MICROWAVE ANTENNAS
KS-15676 HORN-REFLECTOR AND WAVEGUIDE SYSTEM

PERIODIC TEST INTERVALS

1.01 This Addendum to Section 402-421-330

Fig. 1 — Axial Ratio Compensator

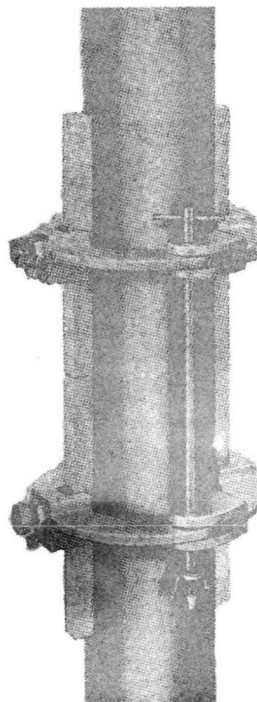
Issue 2 is issued to add a note to paragraph 2.01 advising station forces to caution tower contractors against removing or adjusting the Axial Ratio Compensators on circular waveguides. This issue does not affect the Equipment Test List.

Caution: Adjustments must not be made on Axial Ratio Compensators (Fig. 1) by tower maintenance contractors. These compensators contain critical pressure adjustments for necessary cross-polarization of radio signals and should not be tightened or disturbed in any way.
